Comments on

California High-Speed Rail System Proposed Palmdale-Burbank Section Draft Environmental Impact Report

Richard Meehan and Douglas Hamilton December 1, 2022

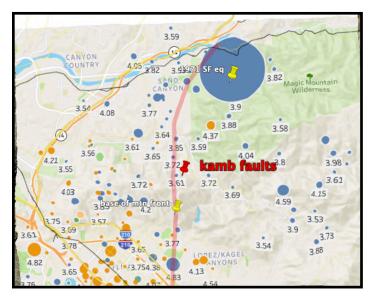
(with one proposed tunnel alignment shown in green) are 9 miles away from the epicenter of the 1971 earthquake that is often taken to be the fault that produced them, which is located in the San Gabriel Mountains off the map to the north. The line does not avoid the indicated Veterans Fault which is known to extend below ground far both east and west from the indicated surface break.

From the time of the earliest investigations of the San Fernando earthquake as by Yerkes and Wentworth,²⁰ geologists have been warning that the San Fernando Valley is underlain by many faults, invisible at the ground surface, of greater or lesser magnitude, including faults with greater potential displacements than the 1971 earthquake. In fact, those authors cautioned that a reasonable design earthquake should be more than Magnitude 7 for this area. But even if the map showing here were a complete catalogue of all of the faults that would show movement at the tunnel depth, one would be left with the question of how so many potential and fatal track disturbances (more than an inch or two) could be reasonably mitigated.

Section 3.8 DEIR:

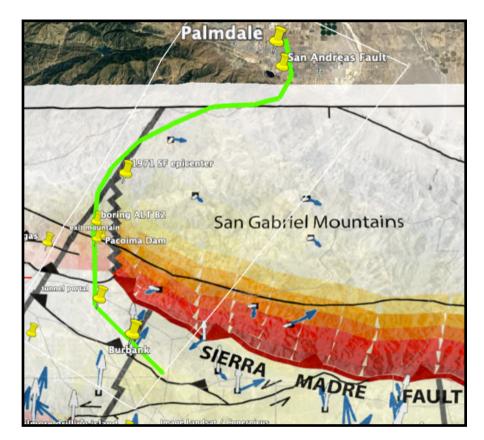
However, it is likely that not all faults in the ANF have been mapped because of limited surface evidence and the inherent limitations of surface geologic investigations. Additional geological investigation would occur before final design and construction.

Question: Why does the DEIR not address the Veterans Fault, which is taken by some geologists as the one major seismogenic fault breaking ground in the San Fernando earthquake?
